ITASCA DOCUMENT REVIEW

File No.: 006-01-59

Document Title: "Modification of Rock Mass Permeability in the Zone Surrounding a Shaft in Fractured Welded Tuff" by John B. Case and Peter C. Kelsall (SAND86-7001, March 1987)

Reviewer: Itasca Consulting Group, Inc.
(K. Wahi, M. Christianson and L. Lorig)

Exhibit 1 Comparison of Reported and Estimated Laboratory Relations Between Effective Normal Stress and Relative Permeability

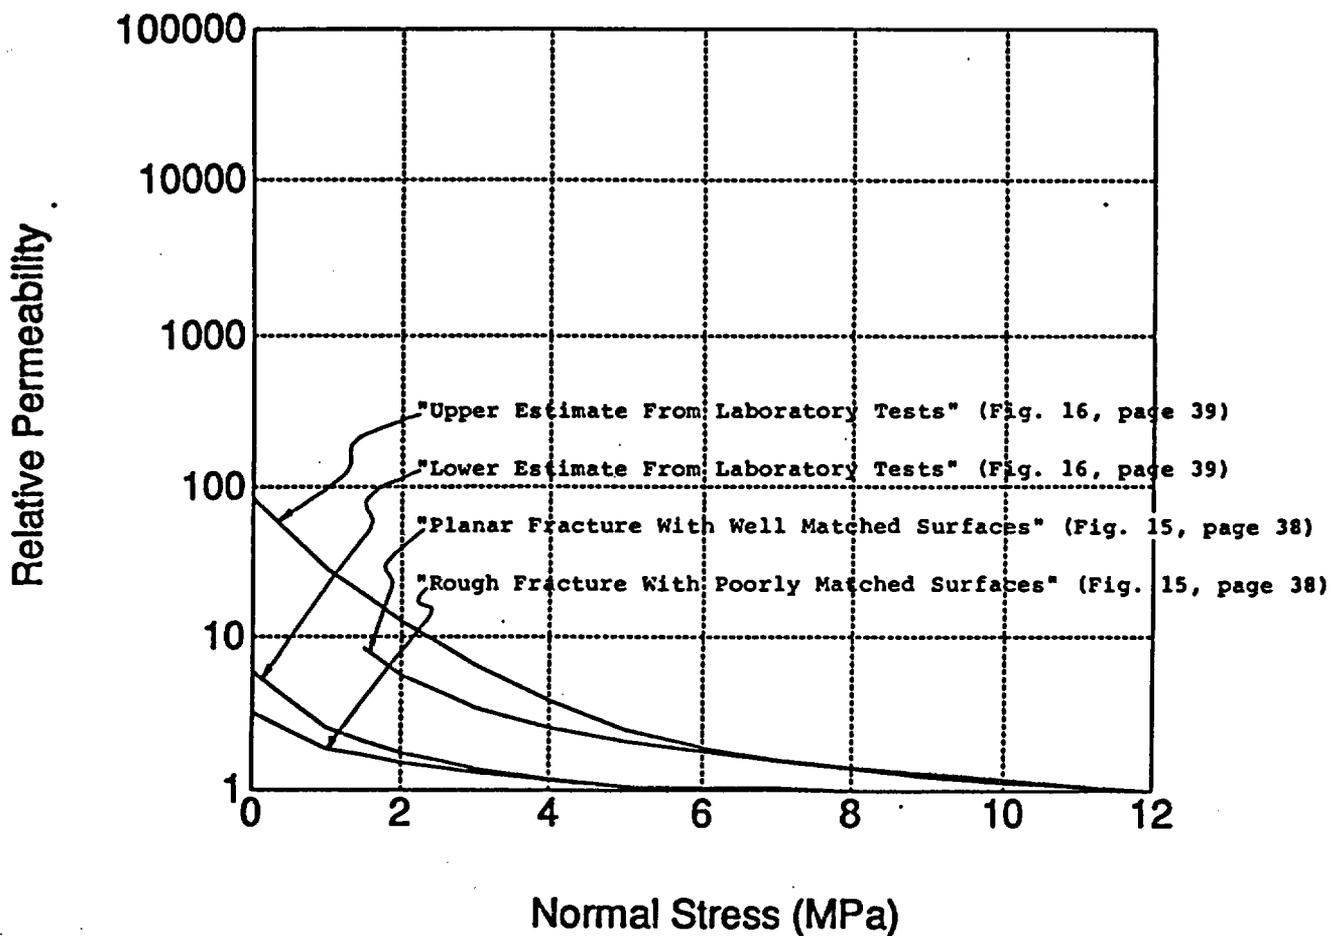
It is not clear how the curves in Fig. 16 (p. 39) were derived. It does not appear that the curves were obtained from laboratory data or from Peters et al. (1984). Exhibit 1 shows a comparison of the actual laboratory data in Fig. 15 (p. 38) plotted on the same scale as estimated upper and lower bounds in Fig. 16. Exhibit 1 indicates that both curves in Fig. 16 lie above the corresponding laboratory data.

Exhibit 2 Comparison of Two Estimated Laboratory Relations [Case and Kelsall (1987) and Peters et al. (1984)] Between Normal Stress and Relative Permeability

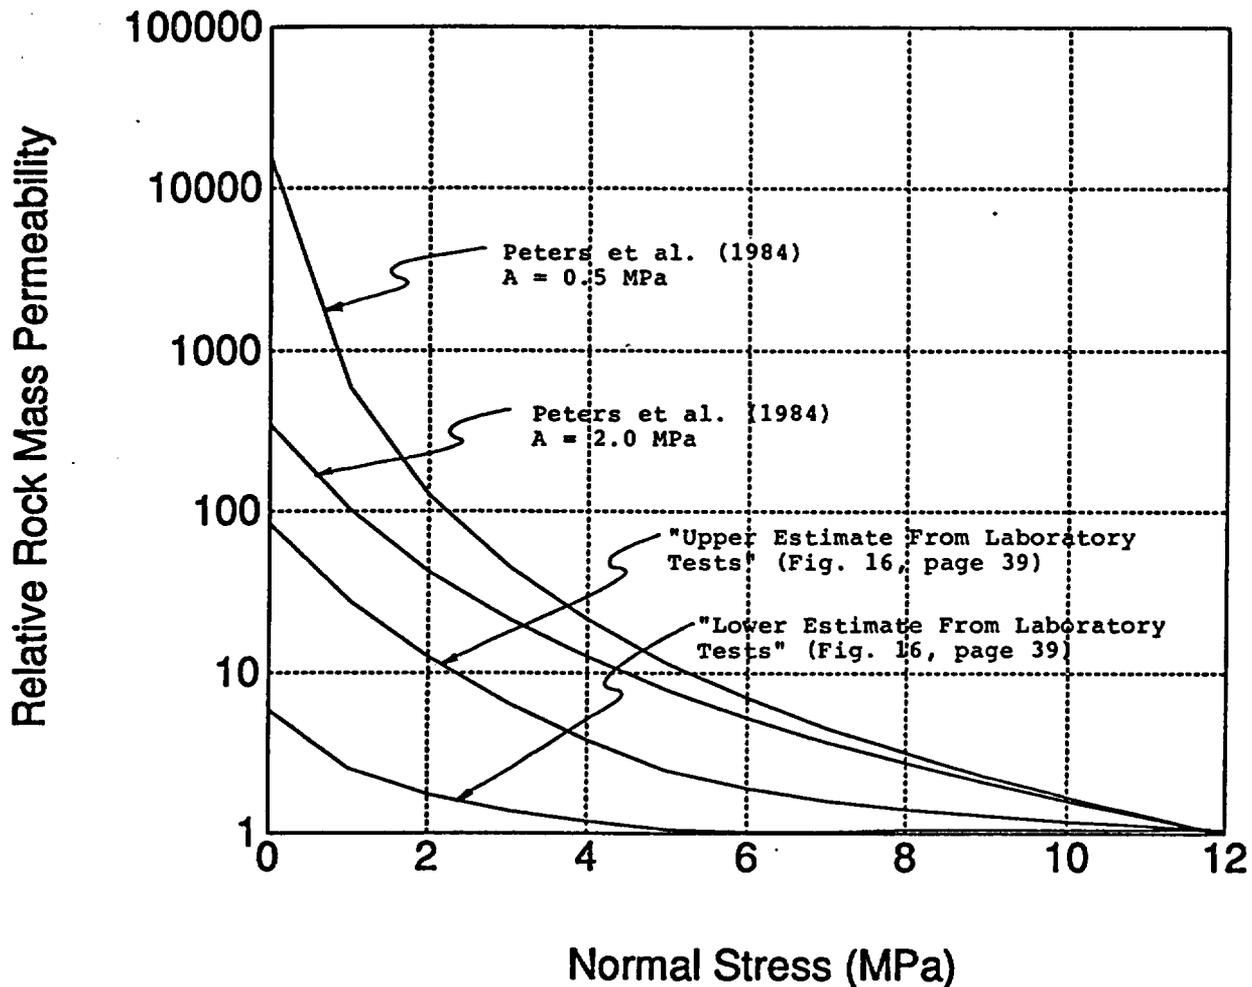
It also does not appear that Peters et al. (1984) has been used to calculate curves in Fig. 16. Rewriting the normal stress-closure relation [Eq. (1)] given by Peters et al., the aperture can be calculated as:

Using Eq. (3) and the values of A and U_n^0 reported in Appendix O of the SCP-CDR (SNL, 1987), the aperture at any normal stress₀ can be calculated. For relative permeability calculations, U_n becomes unimportant, and any changes in the value of A cause relative permeability changes. The permeability ratios are calculated relative to the aperture at 12 MPa normal stress. This results in a relative permeability increase, at 0 MPa, of 343 to

15,625 for values of A of 2 to 0.5, respectively, as shown in Exhibit 2. It is important to note that, at low values of normal stress, the injection fluid pressure becomes a very important factor because the fluid pressure can cause an increase in aperture.
